Docket Item # 8
BAR CASE #2006-0127

BAR Meeting
September 6, 2006

ISSUE: Demolition and Capsulation
APPLICANT: James Bognet and Carole Soloman by Linda Serabian
LOCATION: 509 Cameron Street
ZONE: RM/Residential

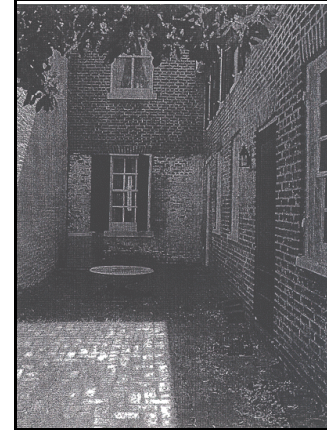
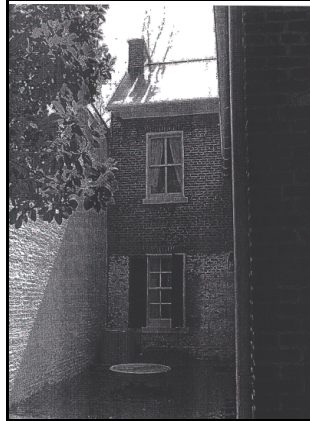
REASON: The Board was concerned about any demolition associated with an early 19th century building and with the intact flounder at the rear of the house. The Board also expressed concern that the propose addition would significantly alter the existing house. In addition, the Board requested an elevation drawing showing the east elevation of the proposed addition.

Update: Since the public hearing of July 5th, the applicant has somewhat modified the proposal and has reduced the overall area to be demolished and capsulated. The rear (north) wall of the flounder section is no longer proposed to be demolished and capsulated with a new rear porch.
